Access Compliance Report Public Rights-of-Way (Curb Ramps)

Main Street: MERCANTILE_WAY		Cross Street: SECOND_ST		Location:	N
ADA ID: RPRK211027170248	Ramp Type: Type 4 - Parallel	Initial Pass/Fail: Fail	Overall Compliance: No	Severity Score:	16

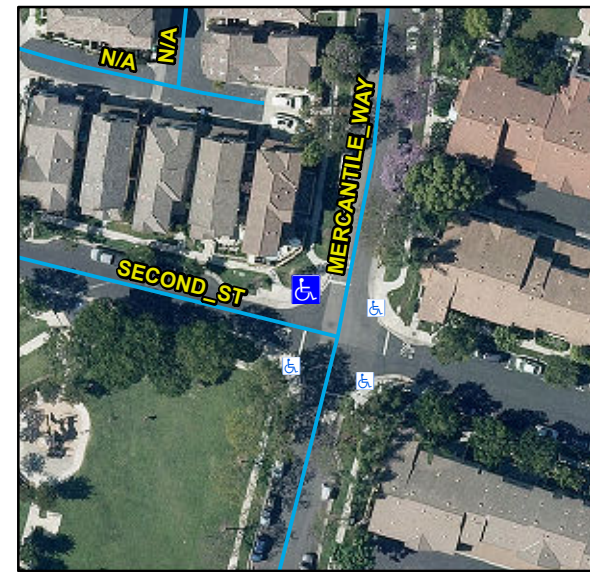
Compliance	Description	Data	Compliance	Description	Data
N/A	Ramp Length LT (in)	117	N/A	Ramp Length RT (in)	112
Yes	Ramp Width LT (in)	88	Yes	Ramp Width RT (in)	88
Yes	Ramp Run Slope LT (%)	0.7	No	Ramp Run Slope RT (%)	8.9
No	Ramp Cross Slope LT (%)	2.7	No	Ramp Cross Slope RT (%)	2.2
N/A	Landing Present	N/A	N/A	DWS Provided	N/A
N/A	Landing Length (in)	N/A	N/A	DWS Contrast	N/A
N/A	Landing Width (in)	N/A	N/A	DWS Length (in)	N/A
N/A	Landing Run Slope (%)	N/A	N/A	DWS Full Width	N/A
N/A	Landing Cross Slope (%)	N/A		DWS Offset Type	N/A
N/A	Landing Movement Obstructed?	N/A	N/A	DWS Offset Left (in)	N/A
	Landing Movement Type	N/A	N/A	DWS Offset Right (in)	N/A
N/A	Landing Shared	N/A			
N/A	Clear Space	Yes			
N/A	Clear Space To Crosswalk (in)	N/A			
N/A	Marked Crosswalk 1	No	N/A	Marked Crosswalk 2	No
	Crossing 1 Direction	SW		Crossing 2 Direction	SE
	Marked Crosswalk 1 Width (in)	N/A		Marked Crosswalk 2 Width (in)	N/A

N/A	Ramp Inside Crosswalk 1	N/A	N/A	Ramp Inside Crosswalk 2	N/A
	Crossing 1 Slope (%)	0.3		Crossing 2 Slope (%)	0.1
	Crossing 1 Cross Slope (%)	0.1		Crossing 2 Cross Slope (%)	1
N/A	Gutter Ponding	N/A	N/A	Curb Slope	4.3
Yes	Gutter Lip Height (in)	0		Road Run Slope (%)	1.2
N/A	Gutter Run Slope (%)	N/A		Road Cross Slope (%)	2.6
N/A	Gutter Cross Slope (%)	N/A	No	Perpendicular Joint Present	No
Yes	Overall Surface Condition	Acceptable			
	Cross Gutter Present?	No		Spandrel Present?	No
	Replace Cross Gutter?	N/A		Replace Spandrel?	N/A

Remove & Replace Curb Ramp With Two New Directional Ramps or Equivalent.
